Re: Corrective Action Plan Air Dispersion Modeling Analysis

Attachment 1
Aerator Status during 7/9-11/2021 IPT

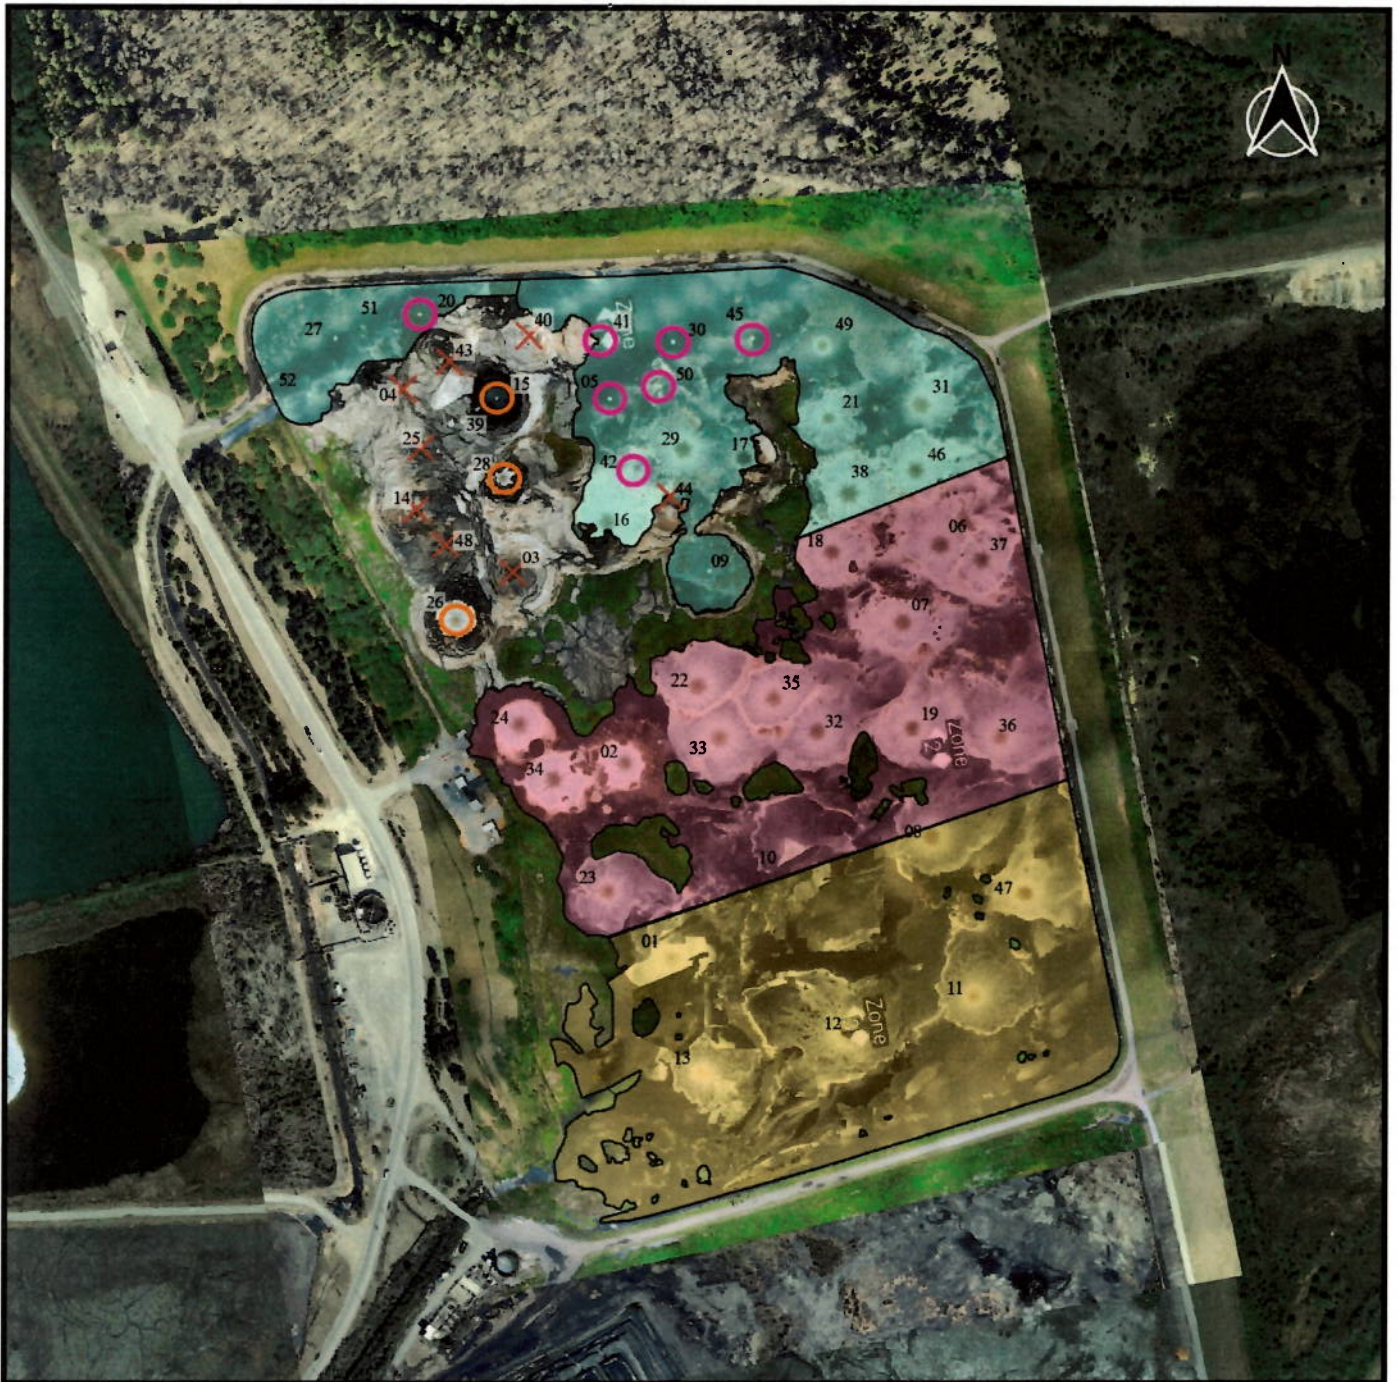
Further review of Attachment 1 (Aerator Status during 7/9-11/2021 IPT, also attached to this letter) raises some questions concerning your response. First, there are three aerators (numbers 26, 28, and 39) that are identified in the legend as "Operational but not included in the model." It appears that the areas immediately surrounding these aerators are liquid surface area that could have H₂S/TRS emissions. Please explain why emissions from these areas were not included in the air dispersion modeling.

In addition, Attachment 1 also identifies several aerators that the legend identifies as "Aerators Running at Night (5:30 pm – 7:00 am)." Please explain if there were any adjustments made to the modeled H₂S/TRS emissions for the limited operation of these

aerators (i.e., were the H₂S/TRS emissions limited in any way for the limited aerator operation or were the maximum H₂S/TRS emissions assumed 24 hours/day, 7 days/week?).
